THE PENNSYLVANIA RAILROAD

FREIGHT CAR

TRUCKS

SIDE FRAME

2D-F10

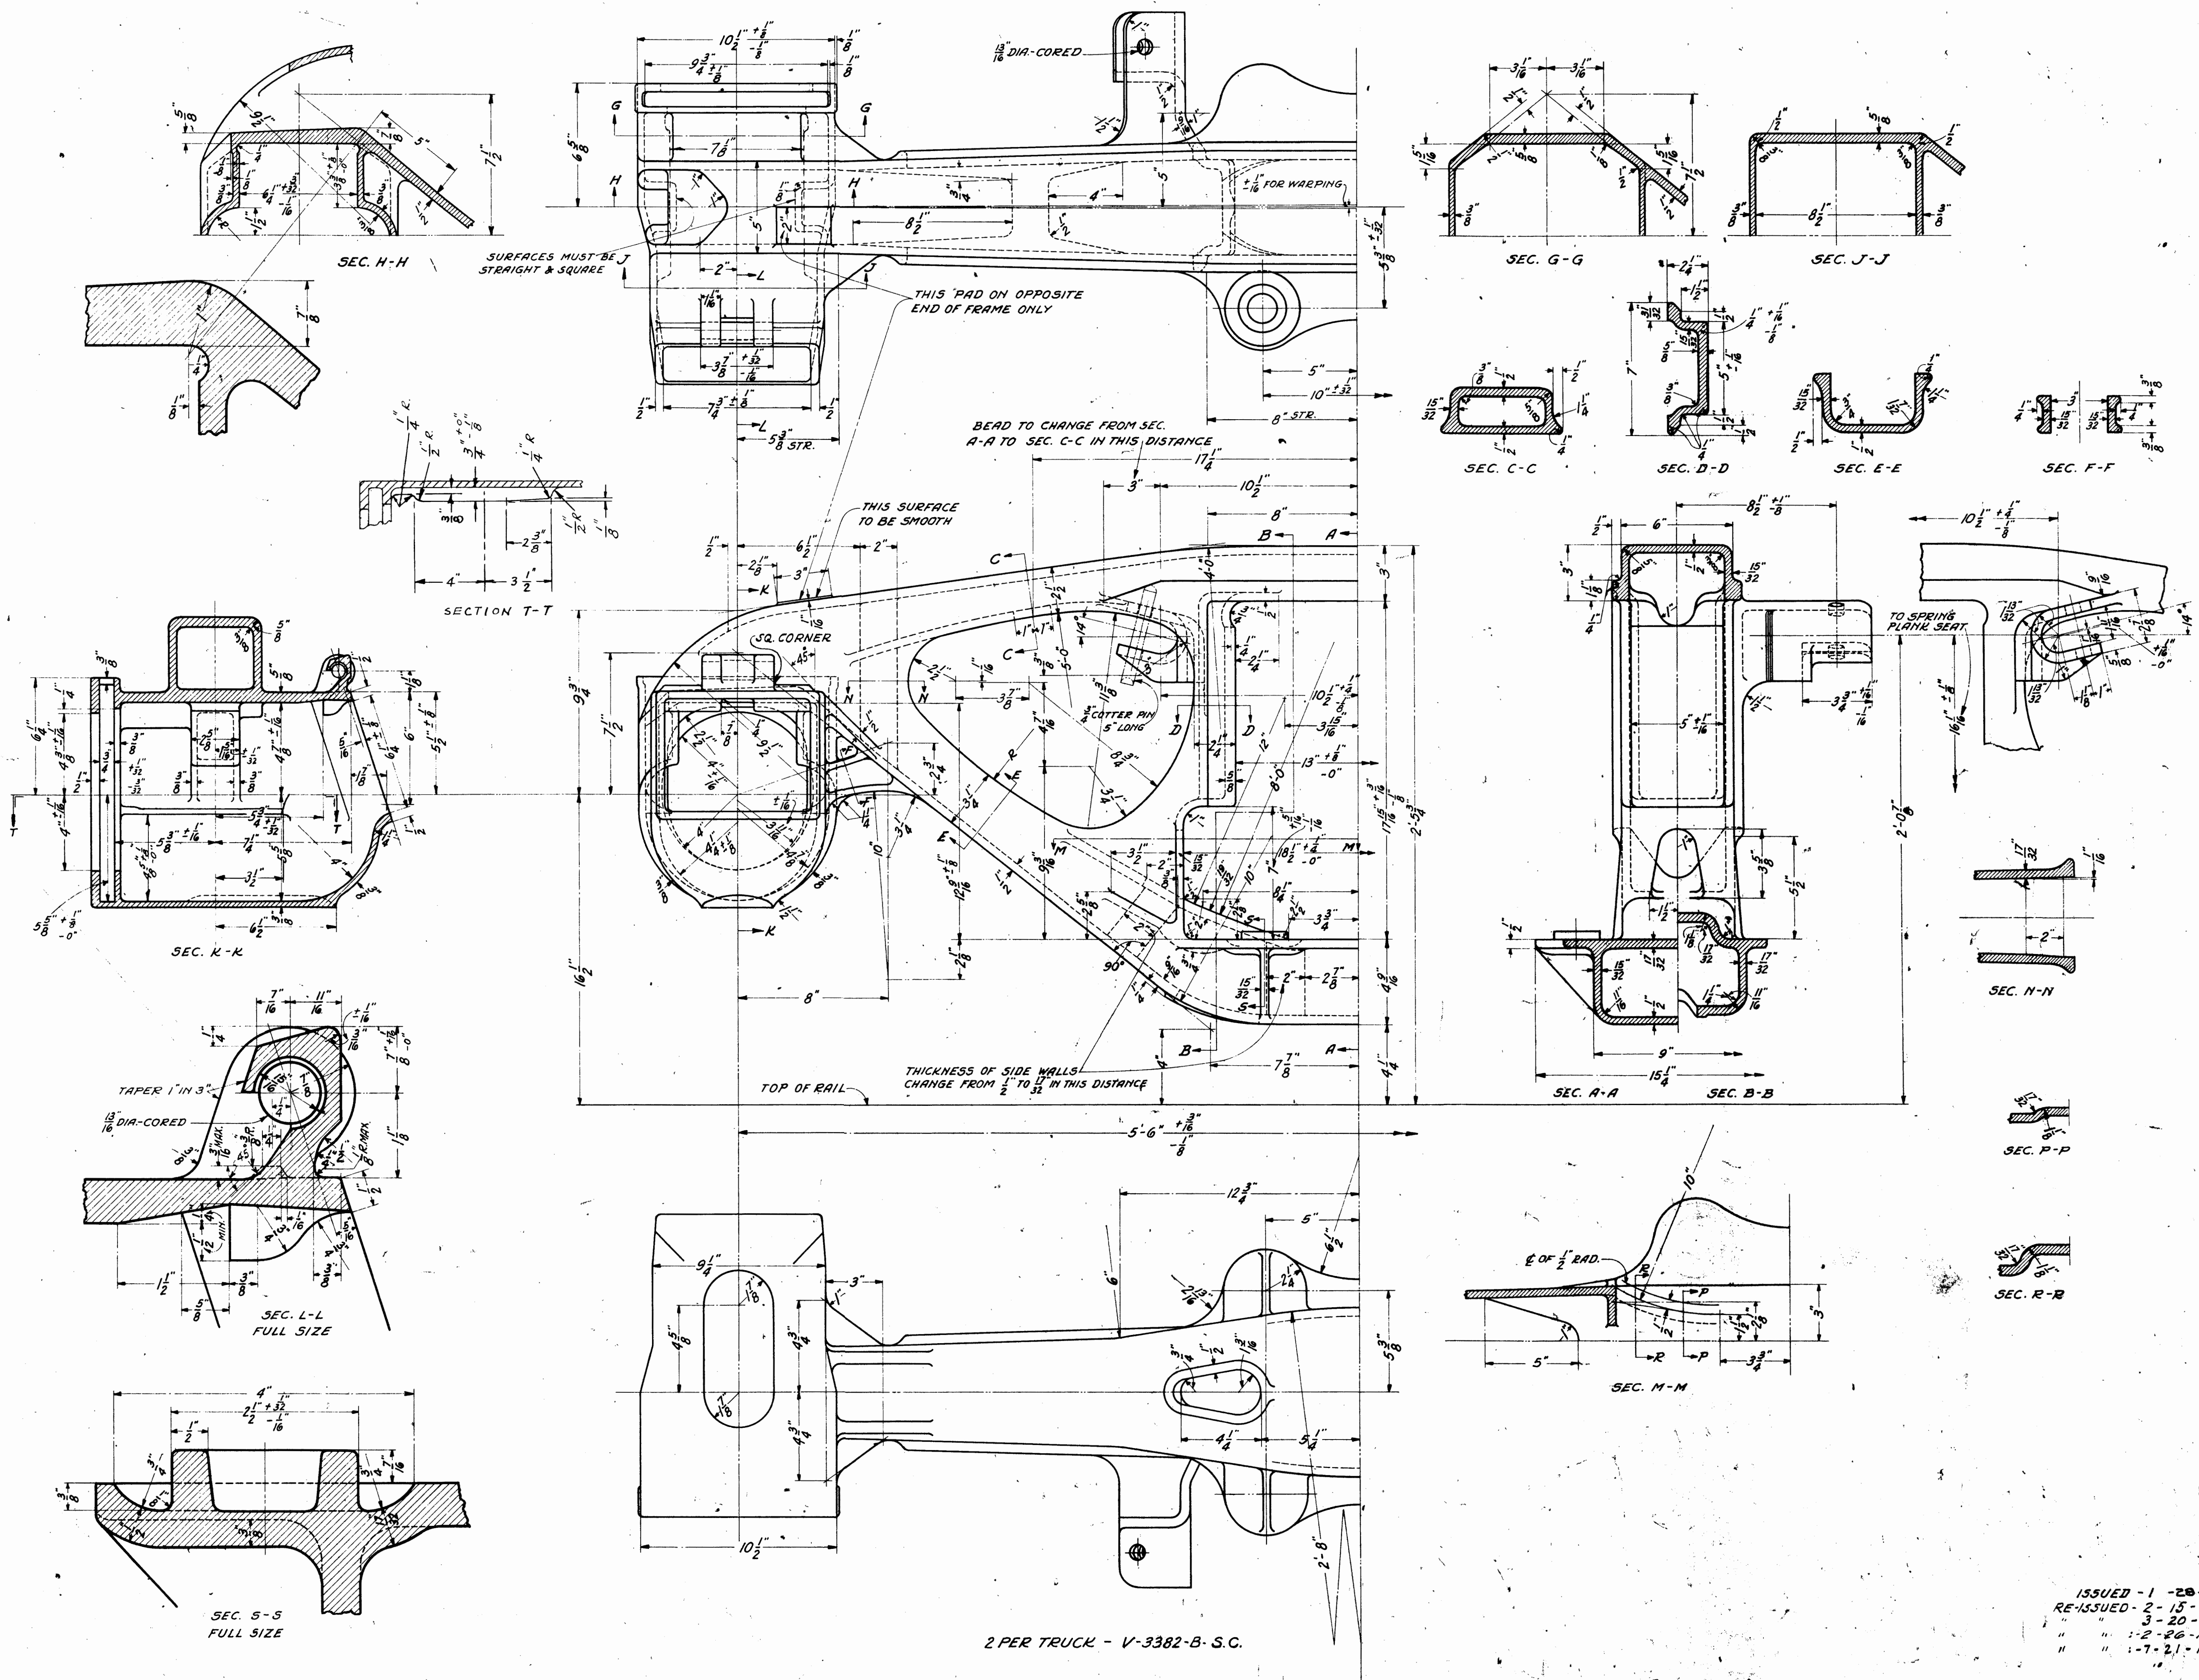
SECTION T-T SHOWING MODIFICATION OF WASTE
RETAINING RIBS TO CONFORM TO A.R.R. REQUIRE-
MENTS ADDED. 7-21-60

DRAIN RIB ON TOP OF JOURNAL BOX HAS BEEN ADDED AND
LETTER 'H' ADDED TO PATTERN NUMBER. 2-15-1935 (F-5-35).
A 1/8 CUT BACK HAS BEEN SHOWN IN FRONT OF LID LUG.
3-20-1935 (F-5-R-35)

WASTE RETAINING RIBS ADDED TO CONFORM WITH LATEST
A.R.R. REQUIREMENTS AND CASTING NO. CHANGED FROM
V-3382-B TO V-3382-B-S.C.
2-26-60
